# Dictation Products Service Bulletin

**Model:** BI-85, BM-77, BM-88

**No.** 27

**Subject:** Original FWD Motor No Longer Available

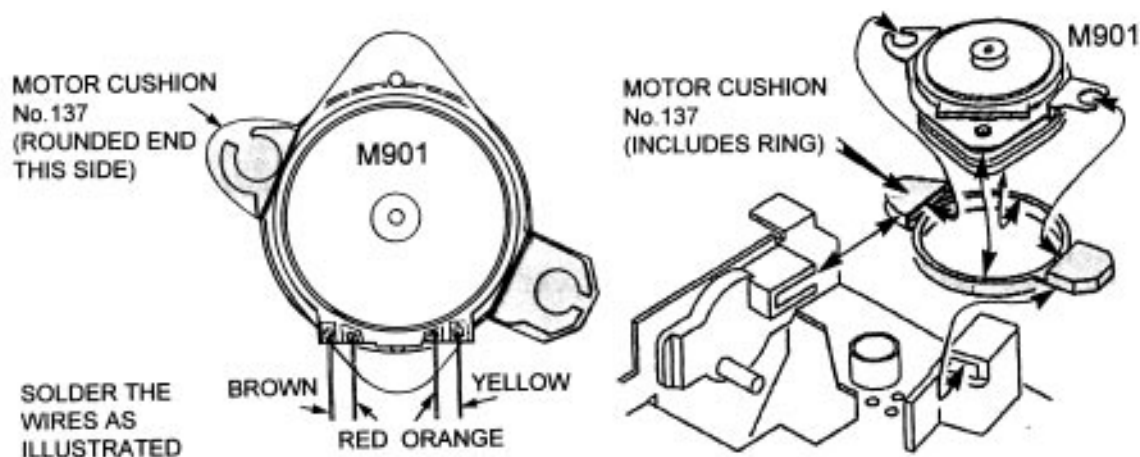
The original FWD Motor is no longer available.

Please use the new FWD Motor ASSY listed below for replacement. This new motor is used for BM-89.

REF	FORMER		NEW	
	DESCRIPTION	PART NUMBER	DESCRIPTION	PART NUMBER
M901	MOTOR (FWD)	1-541-748-11	MOTOR (FWD) ASSY	X-3369-458-1

- Remove the original wiring from the original motor. Remove the original motor from the mechanical chassis.
- Remove the motor cushion No. 137.
- Install the cushion No. 137 on new motor and reverse the procedure.
